Title: Technical Documentation, Comparison of Alternatives to the 2004 Vacuum Vessel Heat Transfer System Design

US ITER Document Number (when applicable):
US ITER 12103-TD0001-R00 Routing for Approval Start Date:
11/22/10

**COMPARISON OF ALTERNATIVES TO THE 2004 VACUUM VESSEL
HEAT TRANSFER SYSTEM DESIGN**

A study comparing different alternatives for the Vacuum Vessel Primary Heat Transfer System has been completed. Three alternatives were proposed in a Project Change Request (PCR-190) by relocating the heat exchangers (HXs) from the roof of the Tokamak building to inside the Vacuum Vessel Pressure Suppression System (VVPSS) tank. The study evaluated the three alternatives and recommended modifications to one of them to arrive at a preferred configuration that included relocating the HXs inside the Tokamak building but outside the VVPSS tank as well as including a small safety-rated pump and HX in parallel to the main circulation pump and HX.

Fig. 3. Alternative 3 schematic – distributor and collector in upper pipe chase.

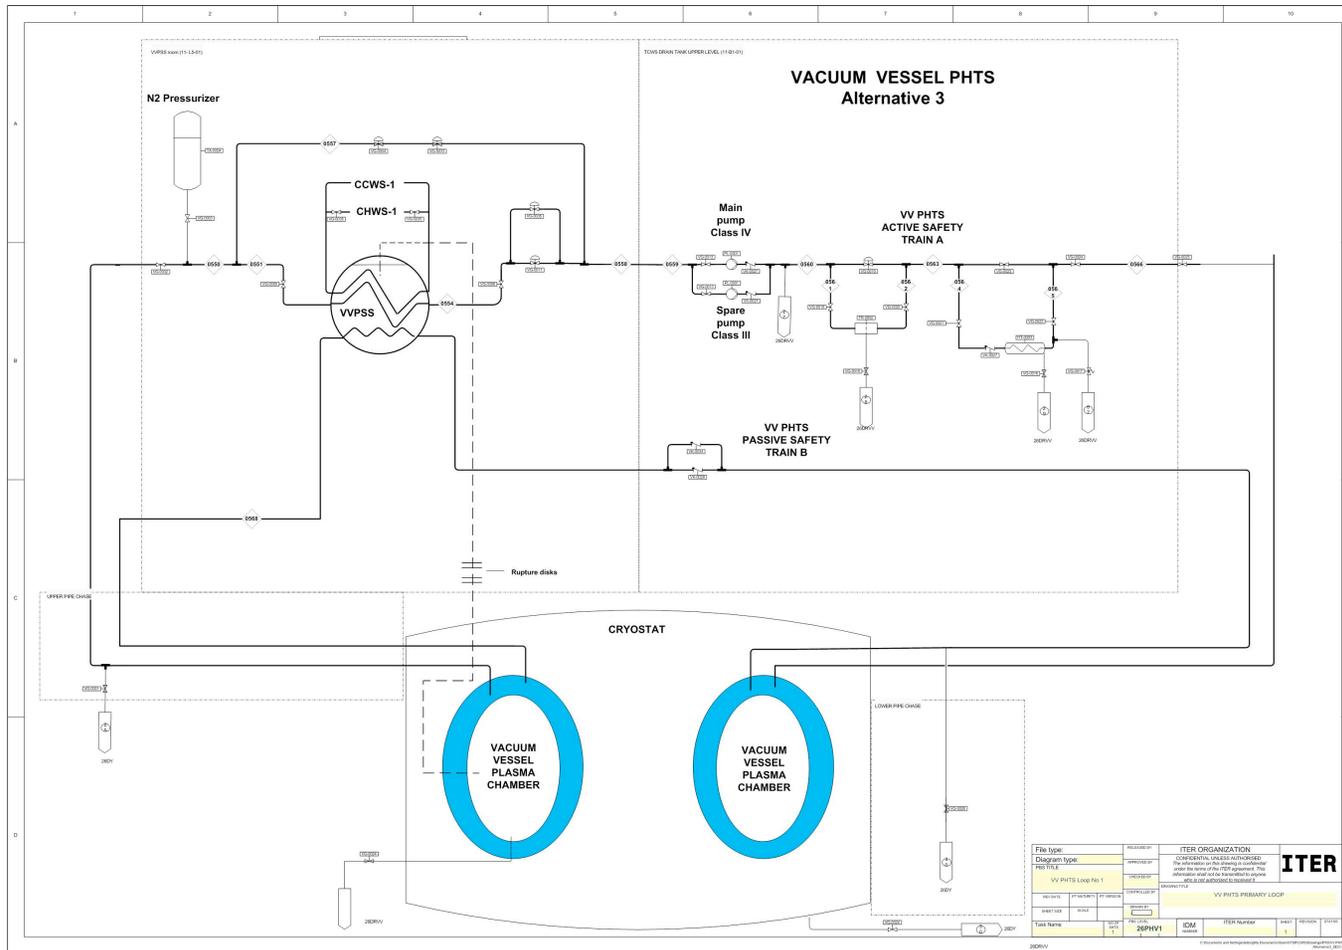
Alternative 3 also has one main forced circulation loop with a small safety-rated pump in parallel with the main circulation pump and one natural circulation safety loop. In this case, both the safety and main loops supply water to the top of the VV with three branch lines and collect the heated water at the top of the vessel through three branches. Here, the distribution header is located in the upper pipe chase as is the collection header. As before, each of these loops has a HX mounted in the VVPSS tank. The main HX is cooled using either CCWS or CHWS water, and the emergency HXs are cooled by natural circulation of the VVPSS water. See Fig. 3 taken from PCR-190.

Alternative 3 has three branch lines each feeding six half-segments (Fig. 6). Using similar arguments, the pressure drop through the VV for this case is $[(18/3) \times (18/3) \times 6]$ 216 times the 2004 design. The pressure drop for alternative designs 1–3 is, therefore, excessive and would result in substantially larger pumps and increased cost. To avoid an increase in pump size, the flow rate through each half-segment could be reduced, resulting in an increase in temperature drop across the VV, or an increased number of branch lines. The number of branch lines would be increased to 18 inlets and 18 outlets for Alternatives 1 and 2 simply because the connections must be at the top and bottom of the half-segments. For Alternative 3 (assuming three half-segments in series are too many from the arguments above), the number must be increased to 9 inlets and 9 outlets (because two half-segments are in series and therefore must include a lower jumper since the inlets and outlets are both at the top of the vessel).

Fig. 4. Jumper configuration for Alternative 1.

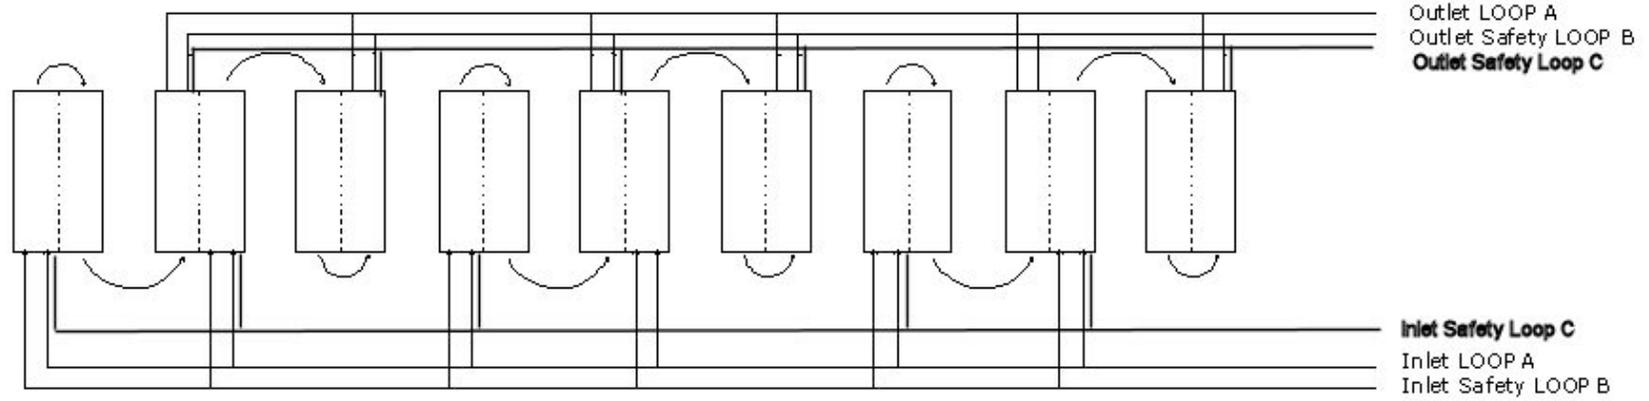
Alternates 1 and 2, as presented in Figs. 4 and 5, each have six inlet branches and six outlet branches with jumpers connecting three half-segments in series. To keep the temperature rise through the VV at 2°C , alternative designs must maintain the same total mass flow rate through the VV. The flow rate through each half-segment is, therefore, $18/6 = 3$ times higher than that of the 2004 design. Since pressure drop through each half-segment is approximately proportional to the square of the flow rate (assuming flow areas remain the same), then the pressure drop through each half-segment is nine times the 2004 design. Additionally, because Alternatives 1 and 2 connect three half-segments in series, the total pressure drop through the VV is, therefore, $[9 \times 3]$ 27 times that of the 2004 design.

- 6) **Draining and Drying** – The 2004 system drains from the bottom of the VV (or near the bottom). In Alternatives 1 and 3, three half-segments are in series with the inlet half-segment connected as before, and the other two half-segments connected by jumpers. Unless the lower jumper system can be designed to have a drain, all of the water in the second and third half-segments (going from inlet to

Fig. 7. Proposed configuration of VV PHTS.

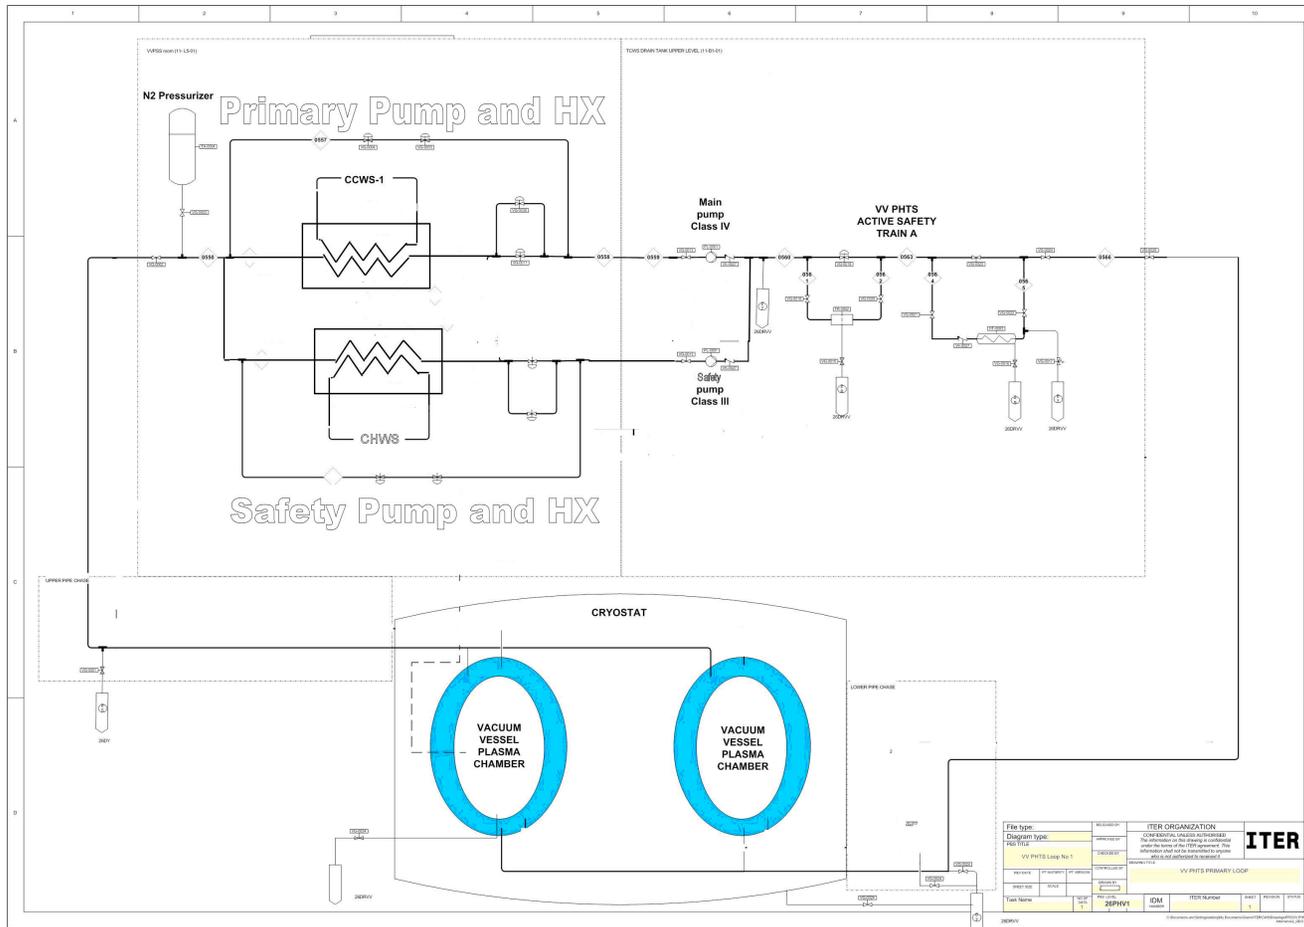
Figure 7 shows this configuration. The separate safety loop design was eliminated because it could not be isolated from the main loop in the event of a pipe break and therefore would offer no additional protection for this event. In order to simplify the design, a small pump and HX system placed in parallel to the main pump and HX was designed to provide the required 40 kg/s, adding defense in depth under loss of power accident scenarios. This can be accomplished by providing appropriate safety-rated electrical power to the pump and using the CHWS on the secondary side of the HX. Because of overpressure or steam generation issues arising when the HXs are placed inside the VVPSS tank, both main and safety HXs should be placed outside the VVPSS tank. Because they are relatively small (the volume of the main HX is ~ 6000 liters and the emergency HX is ~ 60 liters) and the second coolant loop used in the 2004 design is eliminated with this alternative, space should be available to locate these HXs in the Tokamak building. By using the original configuration for branch piping (18 inlet and 18 outlet), the need for reevaluating the heat transfer inside the VV is eliminated since flow direction and velocities will be exactly the same as those in the 2004 design. There are no pressure and temperature differentials across half-segment walls that could lead to additional stresses in this region. Additionally, this configuration eliminates the need for half-segment to half-segment jumpers that potentially would be difficult to locate because of space limitations in the lower region of the VV. This preferred configuration is summarized in the last row of Tables 1 and 2.

- 1) Elimination of the safety loop
- 2) Insertion of a safety-rated HX cooled by the CHWS in series with the safety pump (both pump and HX in parallel with the main pump and HX)
- 3) Both safety and main HXs outside of the VVPSS
- 4) 18 inlet and 18 outlet branches connected to the VV with no jumpers

Conclusions

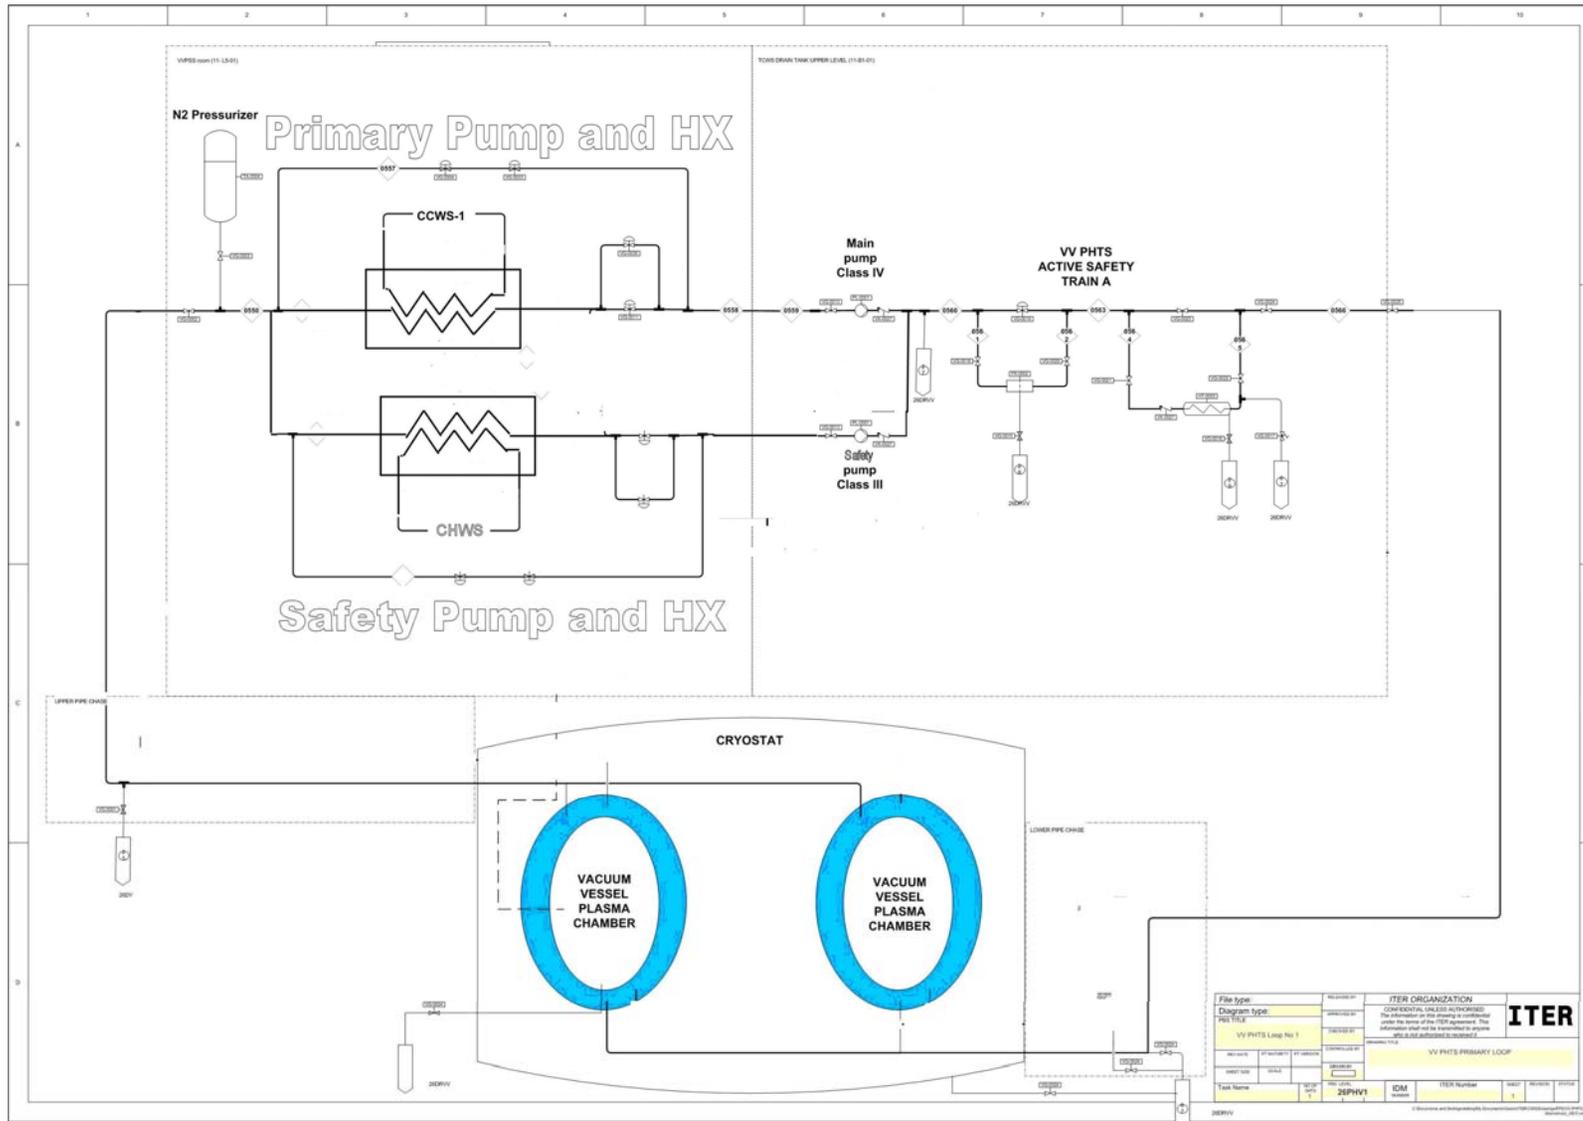
- Common cause failure arguments imply that multiple loops do not serve to add to the overall safety of the system
 - Alternatives 1 and 2 are essentially equivalent

- Calculations indicate that NC cooling does not meet the 40 kg/s flow requirement for safety cooling
 - A pumped safety system will be required to meet this criteria

- HXs not required to be at a high elevation
 - A separate safety loop can be eliminated by maintaining the small pump in parallel to the main pump and including a heat exchanger in that bypass loop - both safety class

- CHWS coolant to be used on the secondary side
- Both main and safety heat exchangers should be located outside the VVPSS system in order to avoid boiling or high pressures in the VVPSS tank

- Because of significant pressure drops introduced through the VV for all alternatives when a 2°C temperature criteria is met, this requirement must be either relaxed or:

- For Alternatives 1 & 2, the branch piping needs to revert to the present configuration 18 inlets and 18 outlets.
 - For Alternative 3, 9 inlets and 9 outlets would be preferred

- Alternative 2 as in PCR-190 with 4 changes
 - Elimination of the separate safety loop
 - Safety rated heat exchanger in series with the safety pump
 - Both safety and main heat exchangers outside the VVPSS
 - 18 inlet and 18 outlet branches – no jumpers
